NORTHEASTERN CONNECTICUT COUNCIL OF GOVERNMENTS

ENGINEERING PLAN REVIEW PERTAINING TO A 3-LOT SUBDIVISION (ASSESSOR'S MAP 41, LOT 85) PROULX STREET BROOKLYN, CT (April 30, 2021)

Division of Property
 "First Time Split"
 Prepared For:
A. Kausch & Sons
 Proulx Street
 Brooklyn, Connecticut

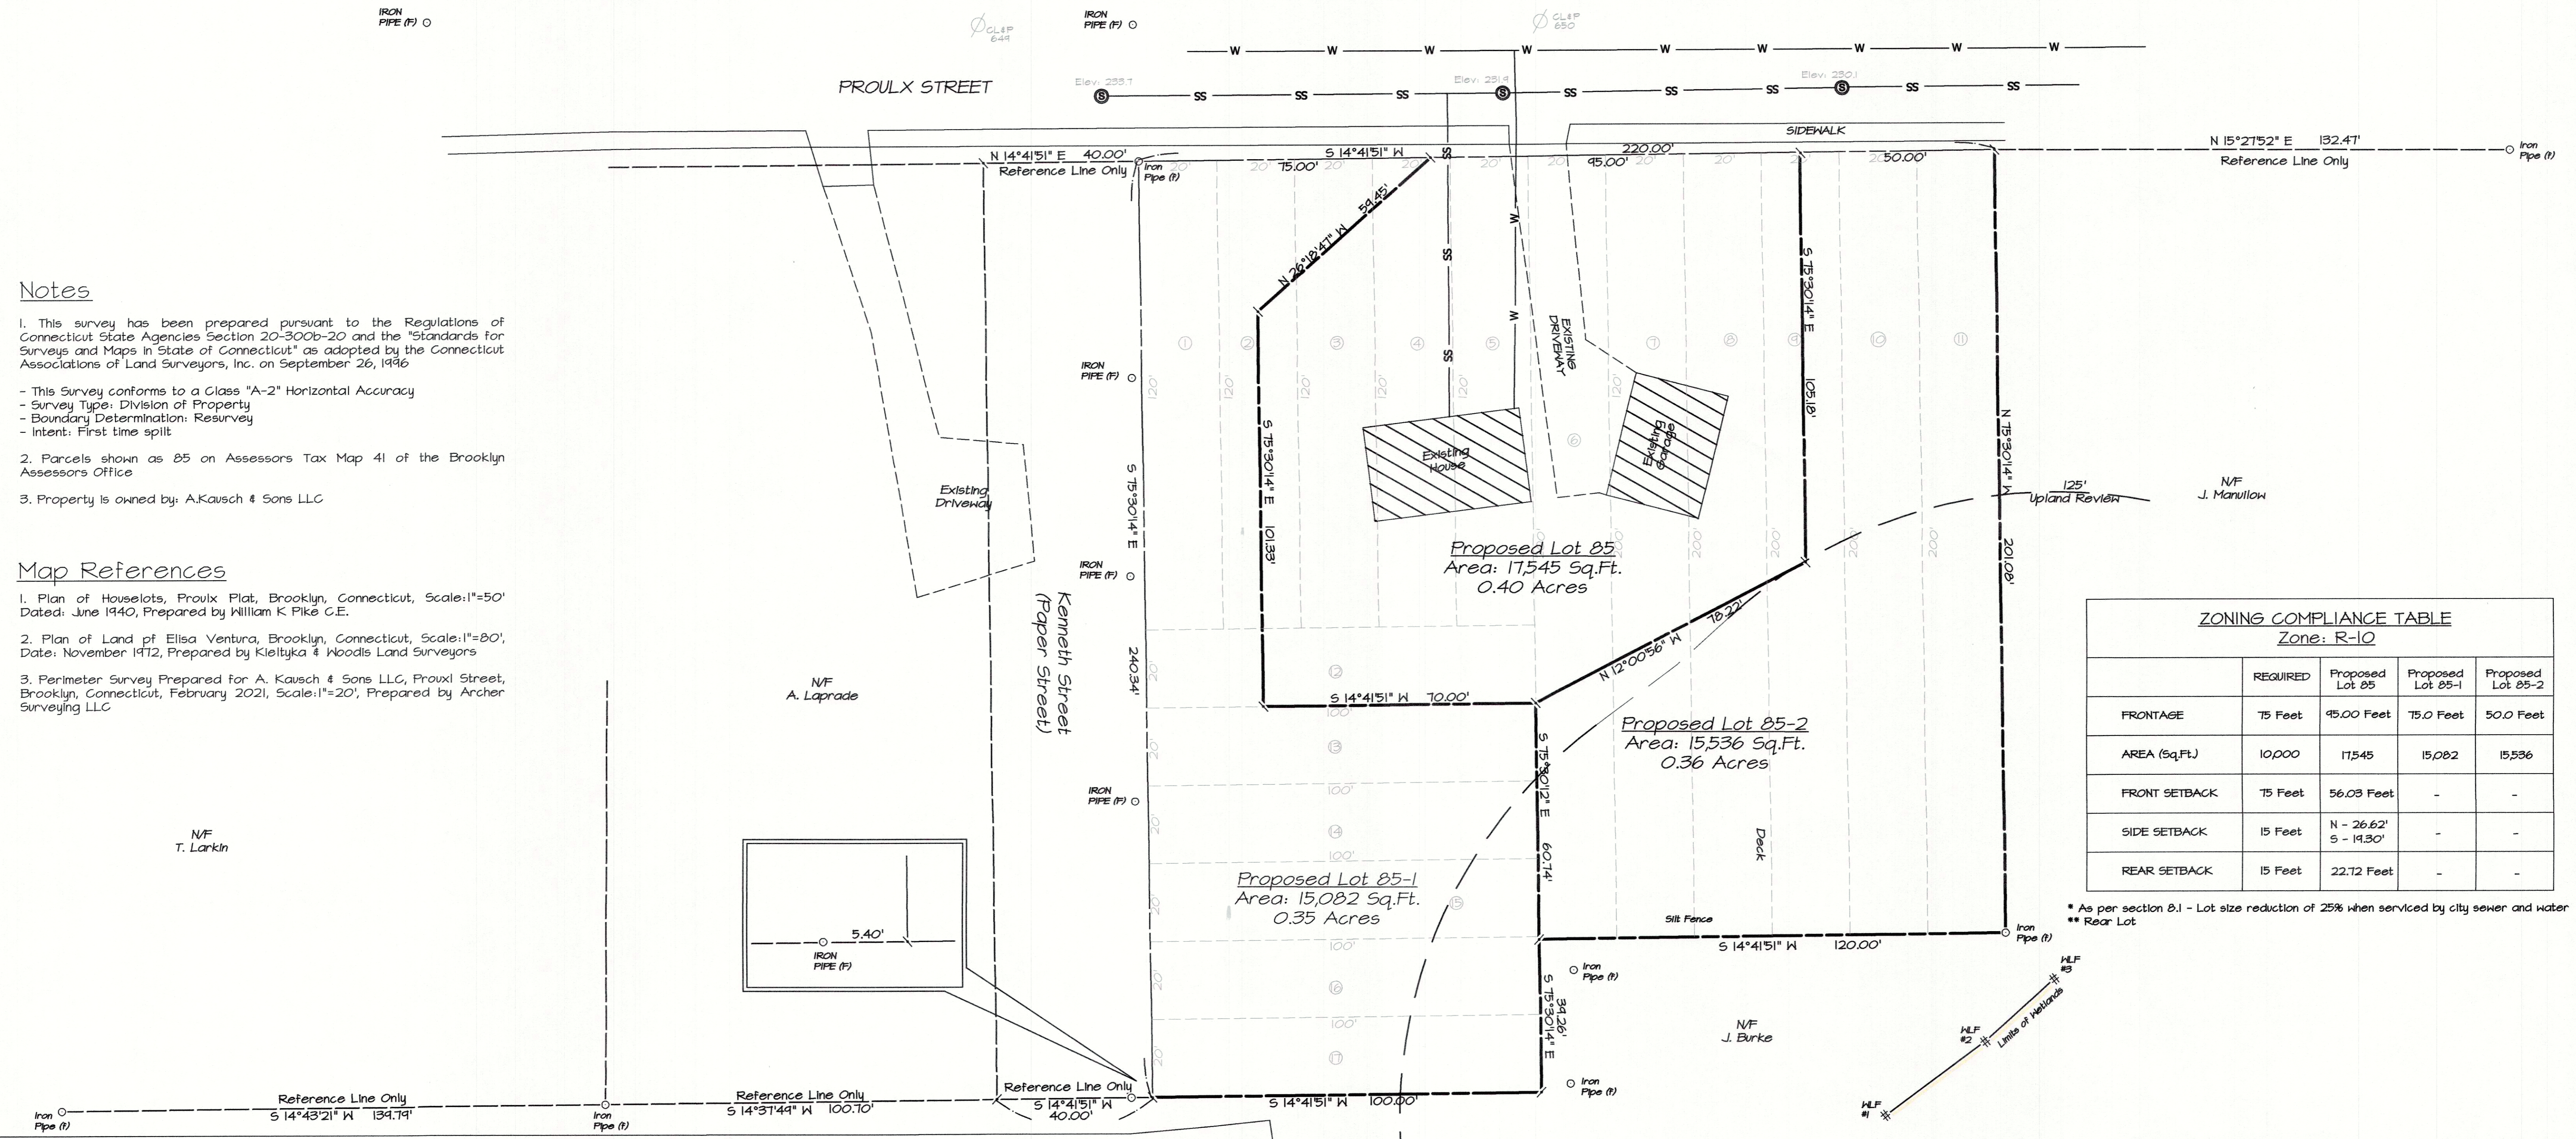
1. The frontage for proposed Lot 85-2 does not meet the requirements put forth in the R-10 Zoning category. The plan shows that the frontage along Proulx Street is only 50' and not the required 75'.
2. The "Zoning Compliance Table" incorrectly shows "Frontage Setback" as 75', which is incorrect. It should be revised to reflect a measurement of 35'.

SITE PLAN & GRADING

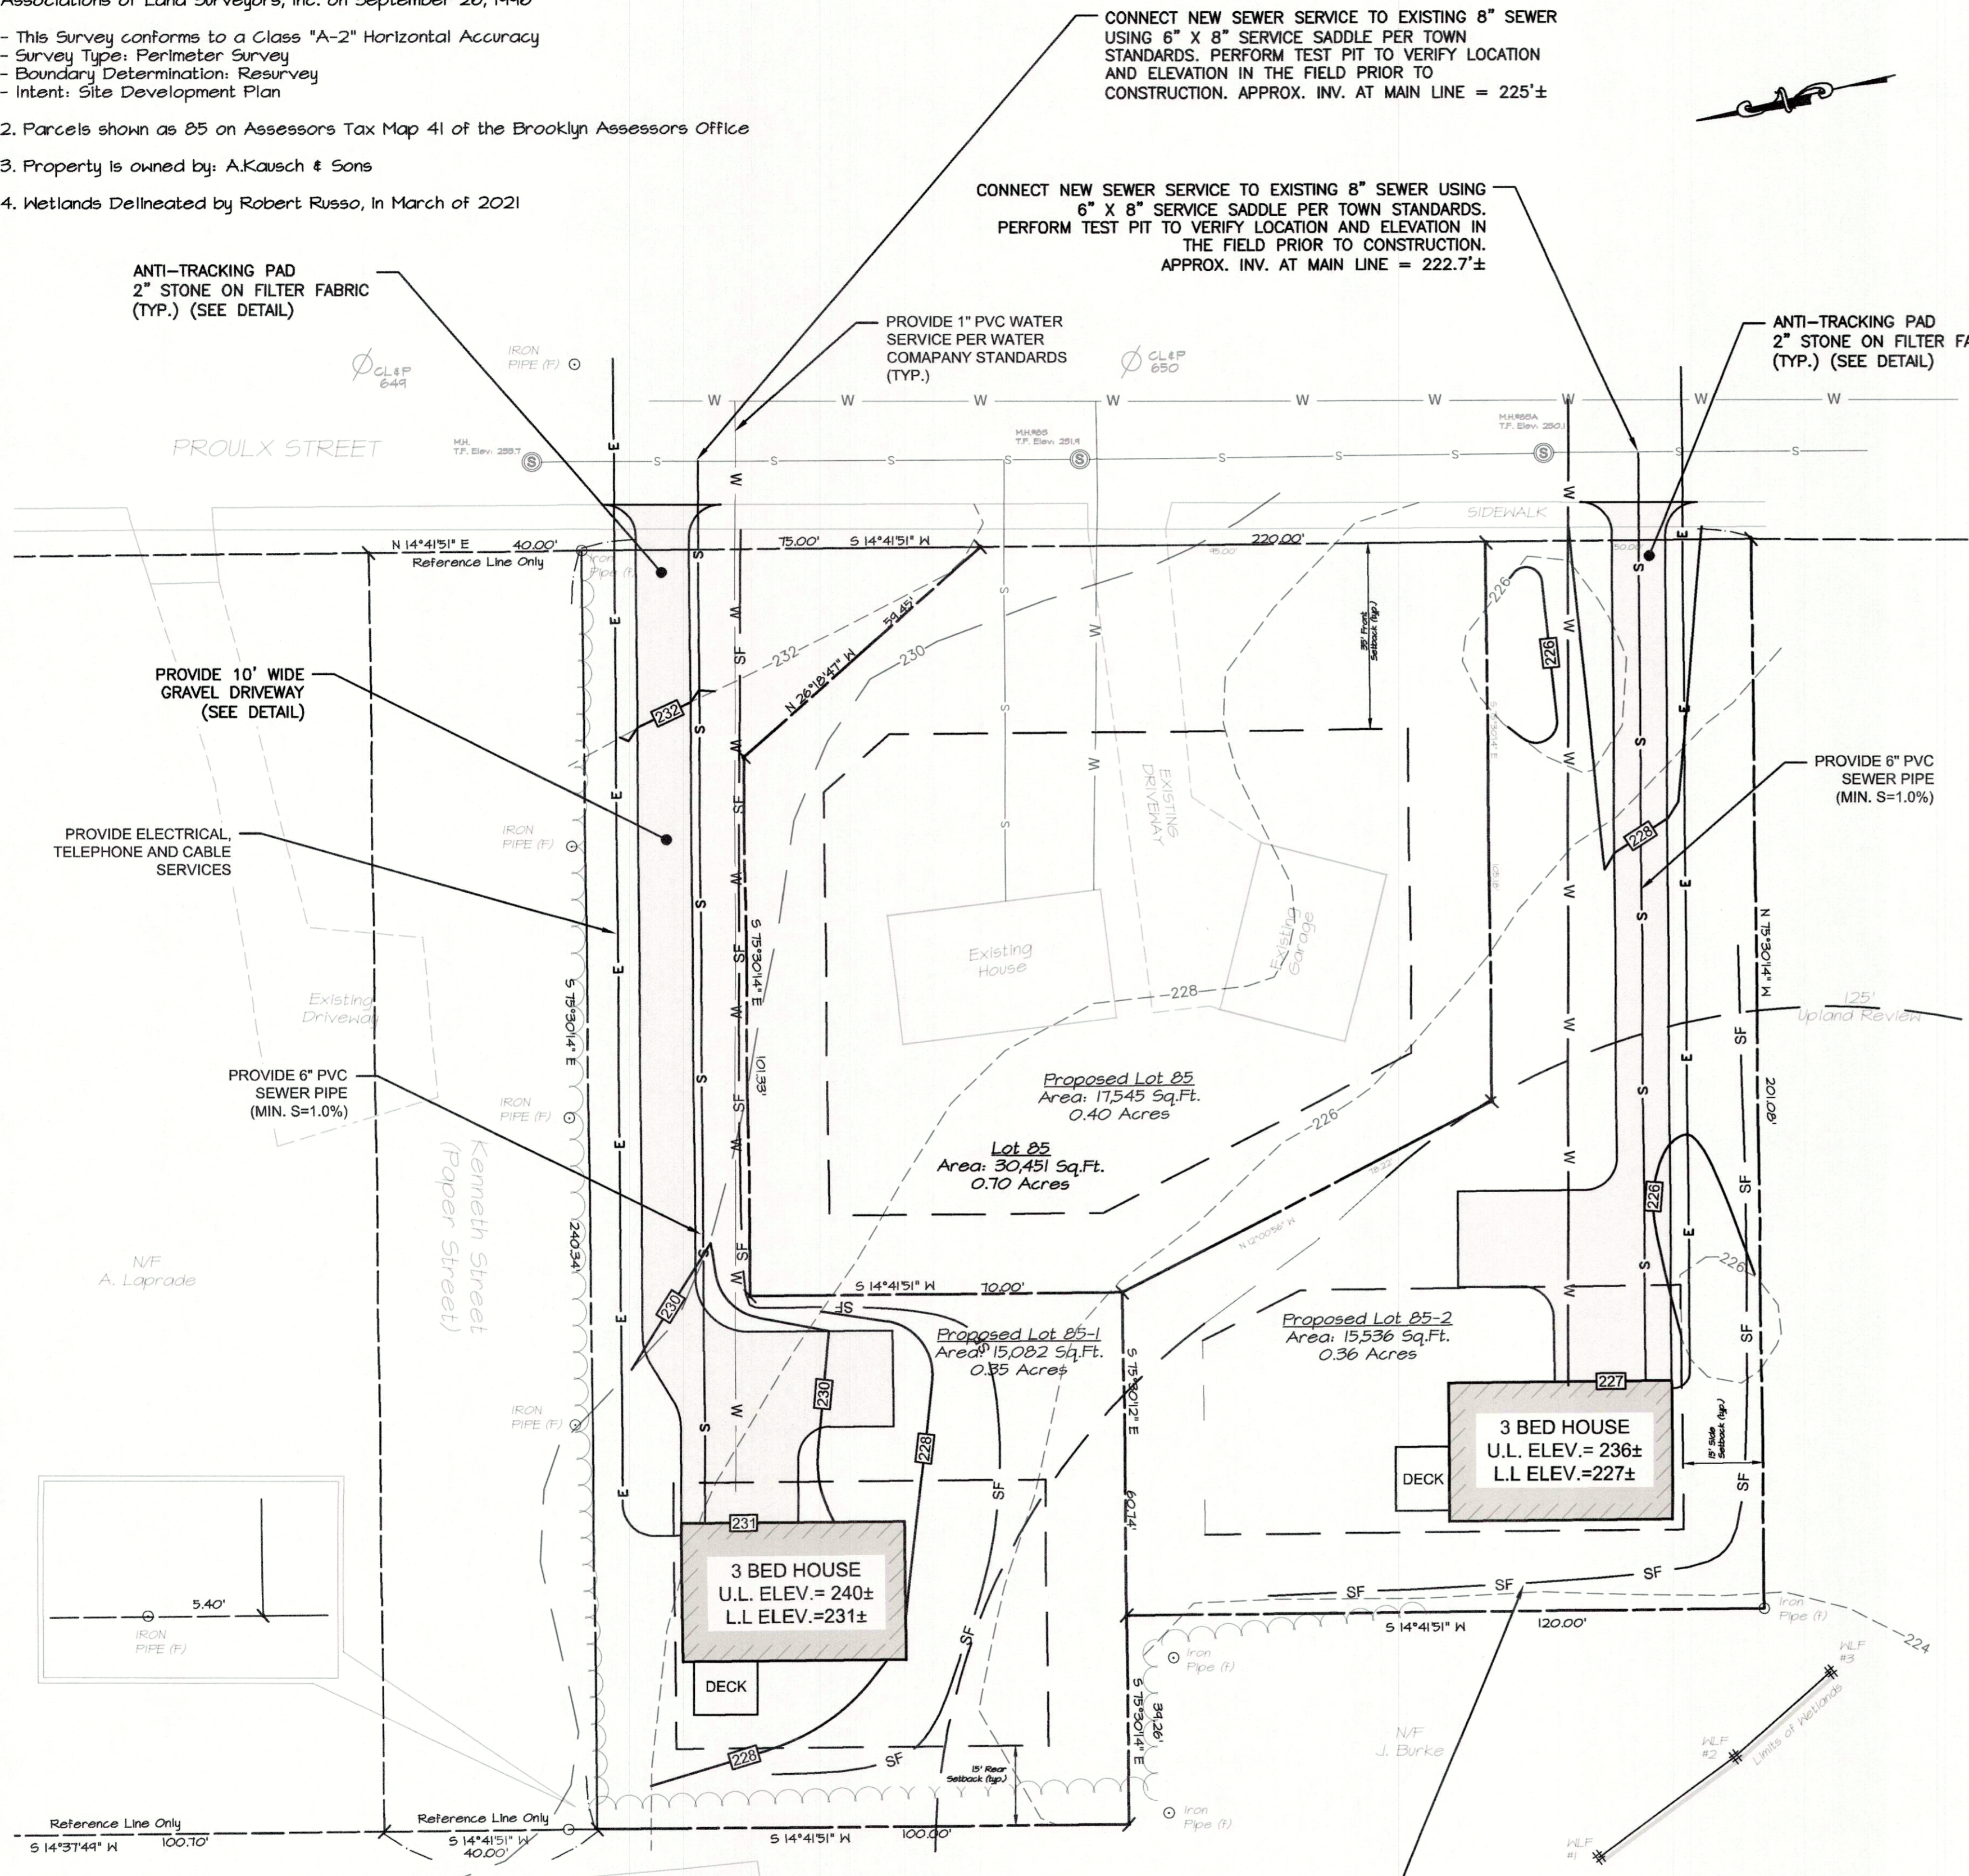
1. Proposed Lot 85-1 abuts Robert Street, a public street, which indicates that west property line is "frontage" on a public street and not a "rear" lot line. The plan indicates that the setback distance is a "rear setback" at 15' rather than a "front setback" of 35'. This discrepancy needs clarification and if in fact the "rear" line is a "front" line, the house footprint (with deck) must be moved to the east out of the setback area.

2. Proposed Lot 85 and 85-1 abut a recorded platted street (Kenneth Street) not yet constructed. Even though there isn't a paved street within this public recorded right-of-way, should the proposed north property lines be considered frontage and the building setback line changed to meet the 35' zoning requirement?

11. Was any consideration given to connecting to the sanitary sewer line in Robert Street?
12. Why isn't the mound (Elev. 226) near the north east corner of the proposed house on Lot 85-2 being eliminated instead of being enlarged as shown on the plan? This needs to be eliminated to improve surface water runoff across the lot and lessen the impact to the house. In the field this looks like nothing more than a pile of accumulated debris.

13. Existing Elevation 226 crossing the proposed driveway on Lot 85-2 has not been shown correctly as a proposed Elevation 226 crossing the driveway and reconnecting to the existing 226 contour near the east property line. This needs correcting.

14. The proposed fill slope opposite the middle of the house footprint on Lot 85-1 needs to reflect a 3:1 (max) slope. As drawn, is a 2:1 slope.
15. Why are so many of the old iron pipe property markers found so far off the Archer Surveying , LLC property lines shown on this plan?

TYPICAL DRIVEWAY CROSS SECTION
NOT TO SCALE

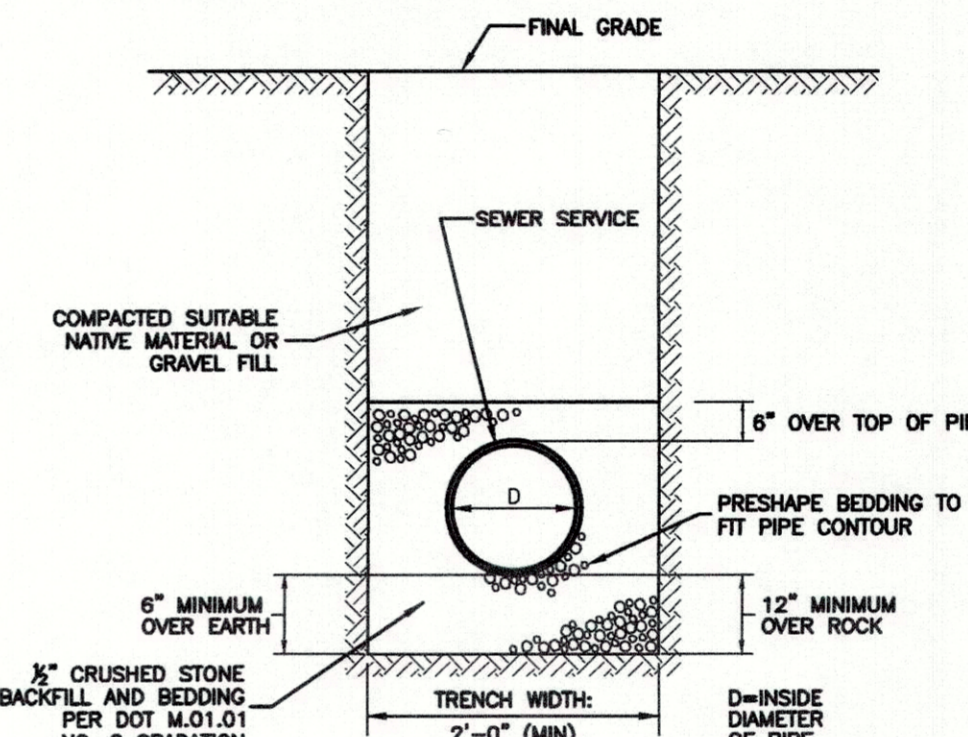
6. The side slopes in the "Typical Driveway Cross Section" are shown to be 2:1 and must be changed to 3:1.
7. No reference whatsoever is made as to the accuracy of the topographic elevation portion of the survey. This is of a concern because field observations seem to indicate steeper elevation changes from the Proulx Street edge of pavement into the property (estimated to be 4'-6' below grade) and no surface mounding (see elevation 226 on the plan) was observed adjacent to the southeast corner of Lot 85 as indicated on the plan. This inconsistency needs explaining.

TRENCH DETAIL: SANITARY SEWER SERVICE
NOT TO SCALE

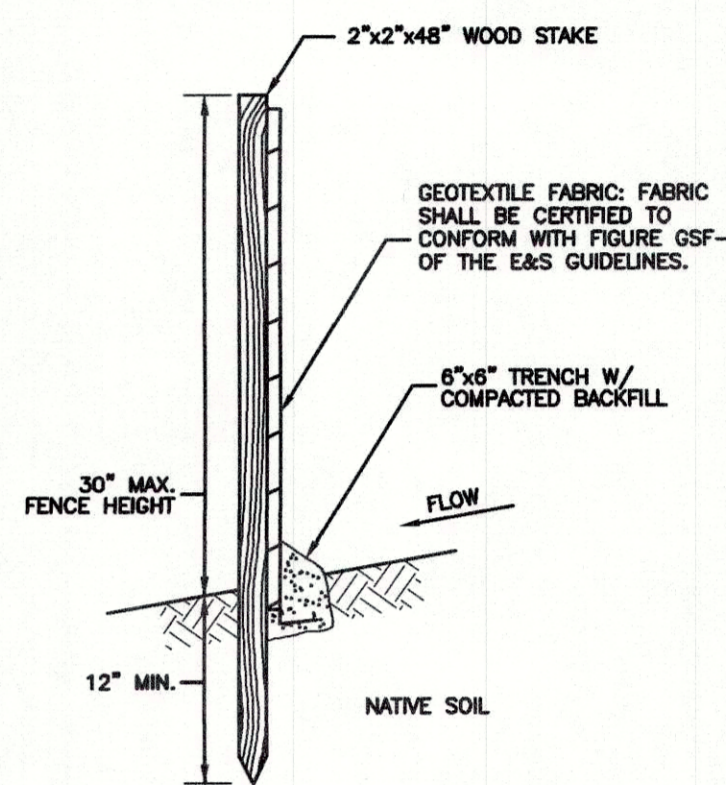
3. Any reference to the CT DOT Form 816 shall be changed to the current Form 818.
4. The "Trench Detail: Sanitary Sewer" and "Typical Service Pipe Trench Detail" need to show detectable warning tape over conduits that are manufactured from non-ferrous material.
